**STARWOOD POWER-MIDWAY, LLC PEAKING PROJECT
(06-AFC-10)
AMENDMENT No. 2**

**SUBMITTED TO THE
CALIFORNIA ENERGY COMMISSION
OCTOBER 2008**

Subject: Starwood Power-Midway, LLC Peaking Project Amendment (06-AFC-10),
Amendment No. 2
URS Project No. 27656131.00700

APPROVED GAS METER AND PIPELINE LOCATION STARWOOD POWER PROJECT AMENDMENT No. 2

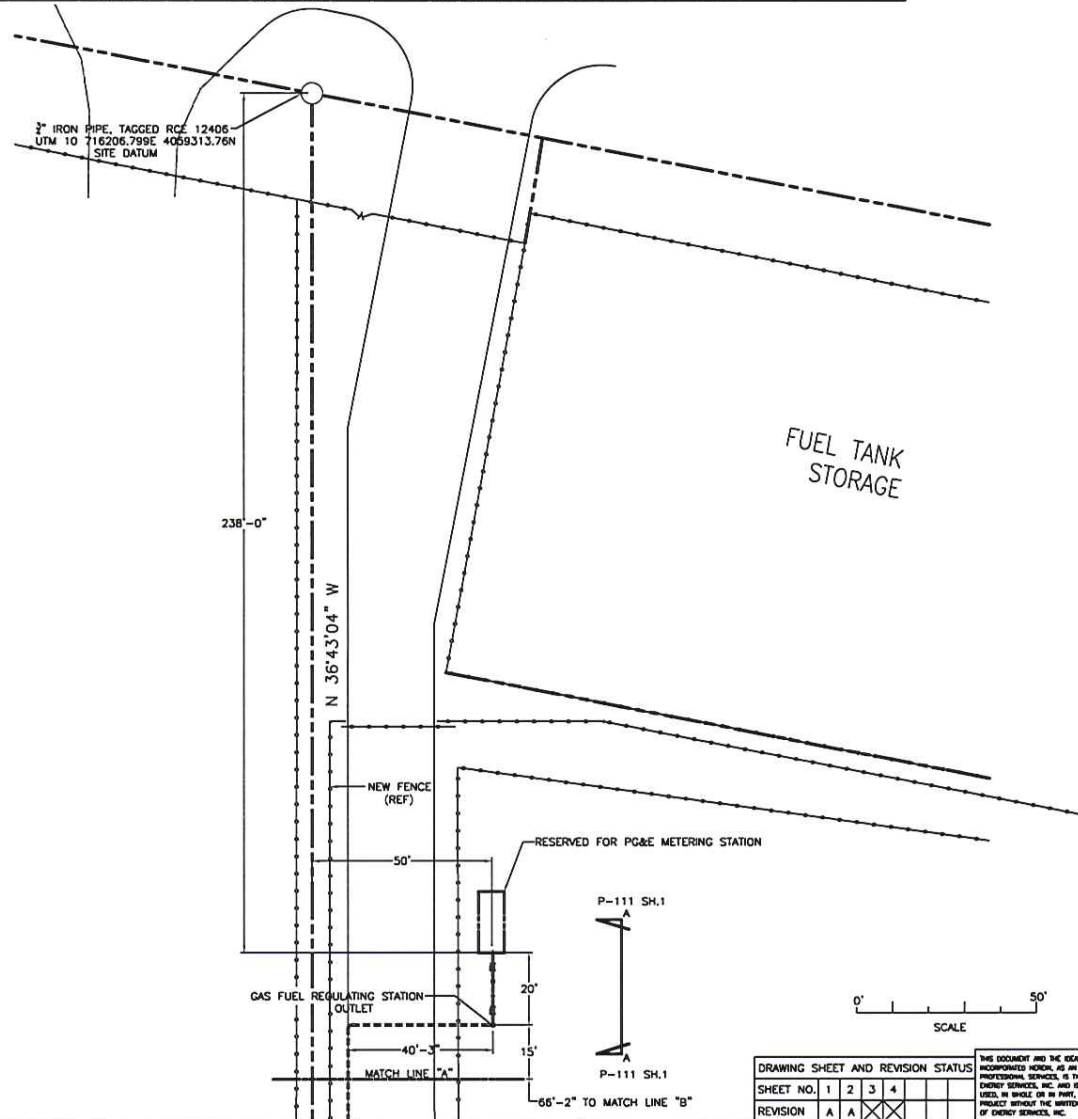
Starwood Power-Midway, LLC hereby petitions for a proposed incremental change to the Starwood Power-Midway, LLC Peak Project Midway 2006 AFC (06-AFC-10). Starwood Power-Midway, LLC is proposing an incremental change to the Midway 2006 AFC that includes an equipment relocation adjustment as shown in Figures 1 and 2.

A plot plan illustrating the approved gas meter and pipeline configuration is provided as Figure 1. A plot plan and aerial image illustrating the proposed gas meter and pipeline configuration are provided as Figures 2 and 3.

PROPOSED GAS METER AND PIPELINE LOCATION
STARWOOD POWER PROJECT AMENDMENT No. 2

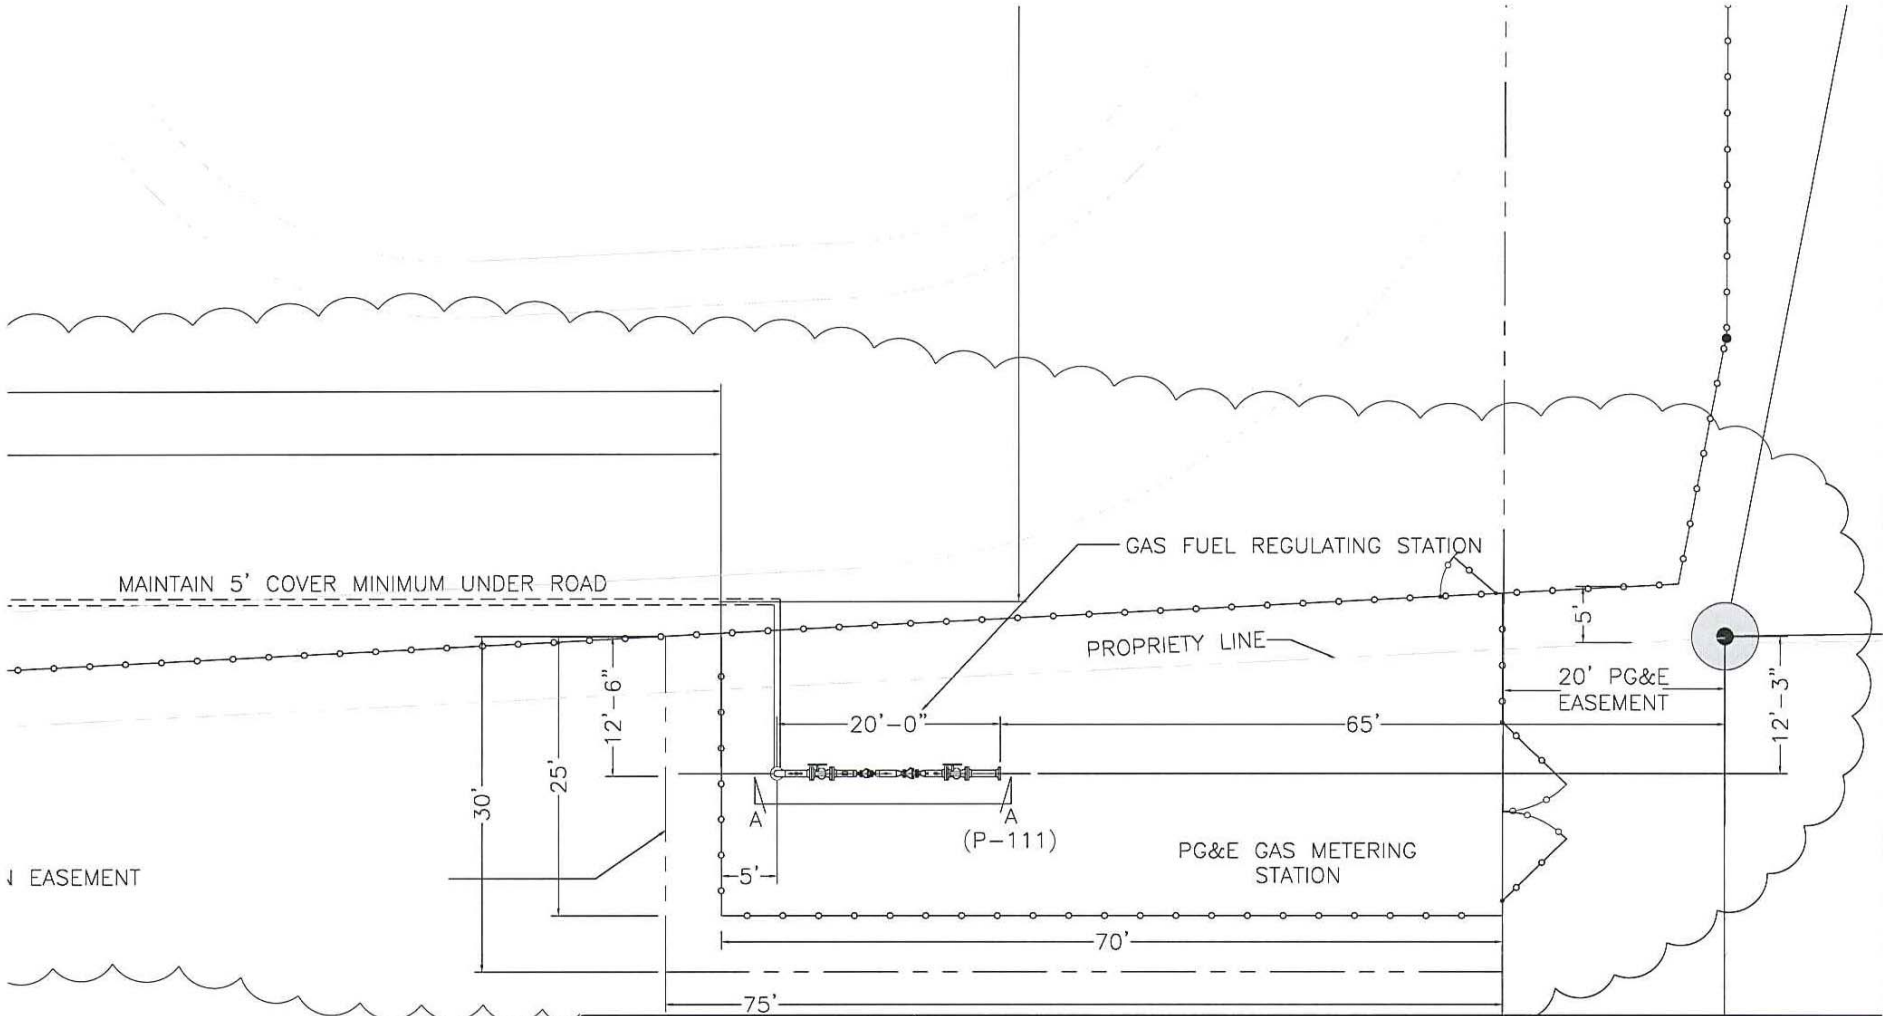
Starwood Power-Midway, LLC is proposing an incremental change to the Midway 2006 AFC that includes relocation of the approved gas line route, meter set, and pressure regulators. The new route for the gas pipeline will change to reflect the new location of the PG&E supply and meters; however it will remain completely on the Midway property. The approved on-site 6-inch gas pipeline is approximately 540-feet in length and extends from the on-site meter set located at the western boundary of the Project site, north to tie into the PG&E Backbone Transmission Line running along (parallel to) West Panoche Road at the northwest border of the Project site. The revised gas pipeline is proposed as a 4-inch pipe, would extend for 600-feet, and tie into the PG&E Backbone Transmission line running perpendicular to West Panoche Road and along the northeast border of the Project site.

In addition, the meter set and pressure regulators will be relocated from the approved location at the western boundary of the Project site, to an off-site leased fenced 25 X 75-foot area located just outside the southeastern corner of the Project site. This will allow for Project connection to the back bone PG&E main Backbone Transmission line which runs through the PG&E Pipeline Right Of Way (ROW). All proposed incremental changes to the Midway Project are further described in Section 2.0, Project Description.

The proposed incremental change to the Midway Project includes relocation of the approved gas pipeline route and connection point to a back bone transmission line which runs through the PG&E Pipeline Right Of Way (ROW) that is on the east side of the Midway Project site. By utilizing this alternative, PG&E will only need to install approximately 60 feet of pipe to reach the PG&E meter run and all of the pipe up to the meter run will be inside the existing PG&E gas line ROW. Starwood is now required to provide a fenced area for the new 25 X 75-foot meter run, which is not within the existing PG&E gas line ROW. The Midway site is fully utilized and grading plans and surface designs have been completed, reviewed, and construction is currently underway. The Petitioner’s plan to provide this additional 25 X 75-foot area for the meter run is with an easement of additional land just outside and parallel to the Project site. The Petitioner has negotiated with the Project’s landlord to provide an easement, which is contiguous to the southern Midway property line, approximately 25 feet wide and 75 feet long. The easement is located on a land locked property which is triangular in shape at 200 X 200 X 100 feet, and is surrounded by the Midway site leasehold, the Wellhead Power plant and the PG&E gas line ROW. The southernmost border of the easement will be the Midway property line and will extend from the Midway property 25 feet south and continue in an east west direction for 75 feet.

The route for the gas pipeline on the Project site will change to reflect the new location of the PG&E supply and meters; however it will remain completely on the Midway property. The approved on-site gas pipeline was approximately 540-feet in length. The new pipeline length is 600-feet. This is considered a minor change. Also the pressure regulators downstream of the meter run, which are required to regulate gas pressure to the gas turbines, be will moved off the Project site and onto the new easement.
